# Sydney Development Control Plan 2012 -55 Pitt Street, Sydney March 2020

This amendment may be referred to as *Sydney Development Control Plan 2012 – 55 Pitt Street, Sydney*.

## Schedule 1 – Amendment to Sydney Development Control Plan

Figure 6.19 Development Control Envelope – 55 Pitt Street

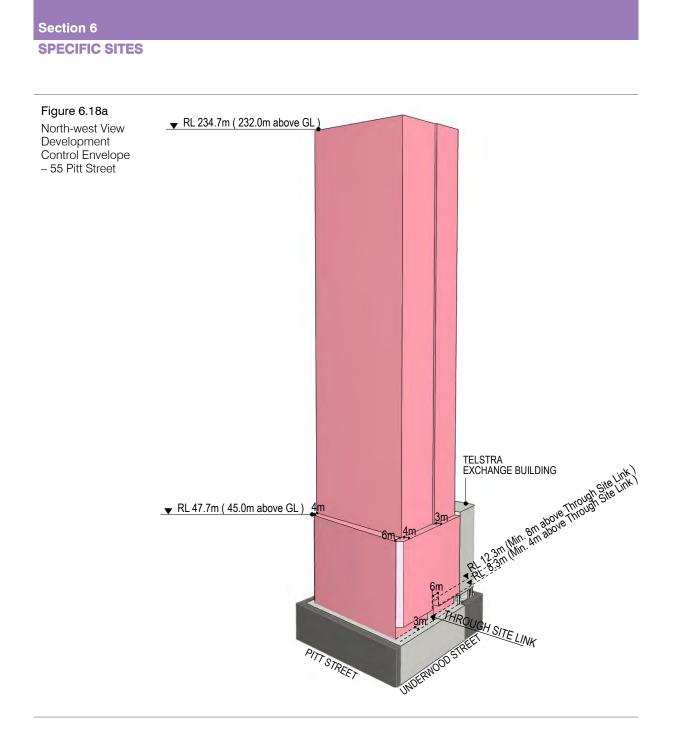
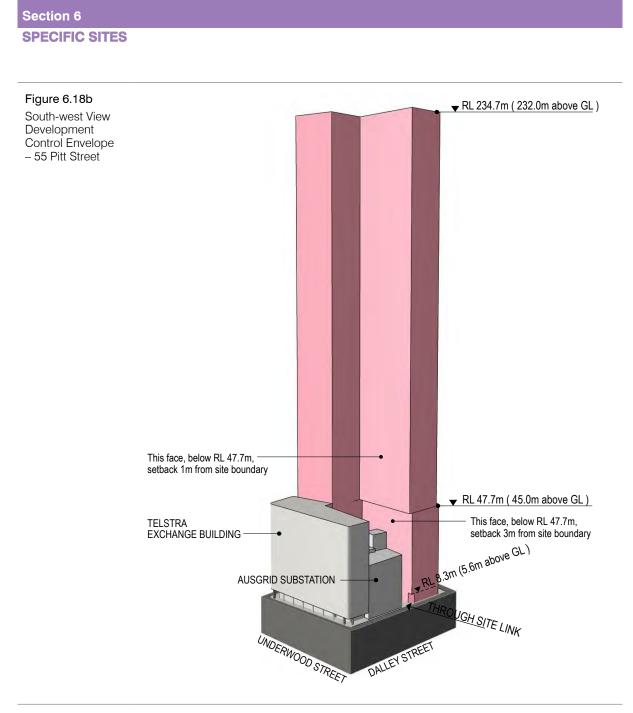
**Development Control Envelope – 55 Pitt Street** Inset new Figure – Development Control Envelope – 55 Pitt Street
